Project	IEEE 802.16 Broadband Wireless Access Working Group < <a href="http://ieee802.org/16">http://ieee802.org/16</a> >	
Title	A Proposal for Construction and transmission of Relay MAC PDU in 16j network	
Date Submitted	2007-05-04	
Source(s)	Qu Hongyun, Sean Cai, Mary Chion, Liu Yang, Chen Yuqin ZTE Corporation 712/2, Liantang Pengji Industrial Park, Luohu District, Shenzhen, P.R.China 518004	Voice:+86-755-26773000 exd. 6614 E-mail: <a href="mailto:qu.hongyun@zte.com.cn">qu.hongyun@zte.com.cn</a> , <a href="mailto:scai@zteusa.com">scai@zteusa.com</a>
Re:	IEEE 802.16j-07/007r2:“Call for Technical comments and contributions regarding IEEE Project P802.16j”	
Abstract	This document presents a relay MAC PDU format for IEEE 802.16j.	
Purpose	Propose the relay MAC PDU construction/transmission for IEEE 802.16j	
Notice	This document has been prepared to assist IEEE 802.16. It is offered as a basis for discussion and is not binding on the contributing individual(s) or organization(s). The material in this document is subject to change in form and content after further study. The contributor(s) reserve(s) the right to add, amend or withdraw material contained herein.

## A Proposal for Rel

Figure 1

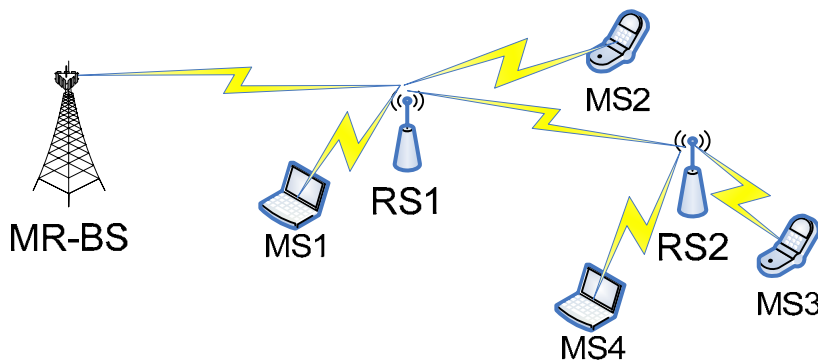
A multihop relay network is illustrated as Figure 1. MR-BS receives PDUs from the network for mobile stations. MR-BS shall create relay MAC PDUs (R-PDUs) for transmission on relay link to the designated RS by encapsulating MS's MAC PDUs to a relay MAC PDU (R-PDU). RS receives the relay MAC PDU and decodes it to regular MAC PDU for its MS.

Figure 2

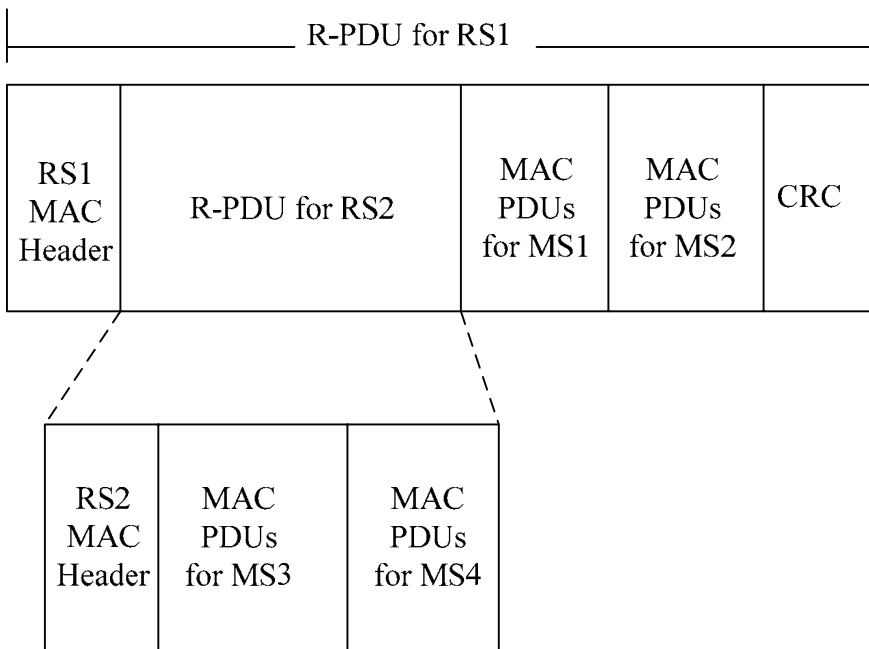
The exemplary format of relay MAC PDU (R-PDU) is illustrated in Figure 2. The R-PDU for RS1 is created by MR-BS and transmitted on relay link to RS1. After RS1 receives this R-PDU, RS1 decodes the R-PDU to R-PDU for RS2 and MAC PDUs for MS1 and MS2. RS1 transmits MAC PDUs for MS on access link and transmits R-PDU to RS2 on relay link. CRC fields can be included in R-PDUs. The PHY burst allocation on which R-PDU is transmitted is addressed to the designated RS which is respected to receive the R-PDU.
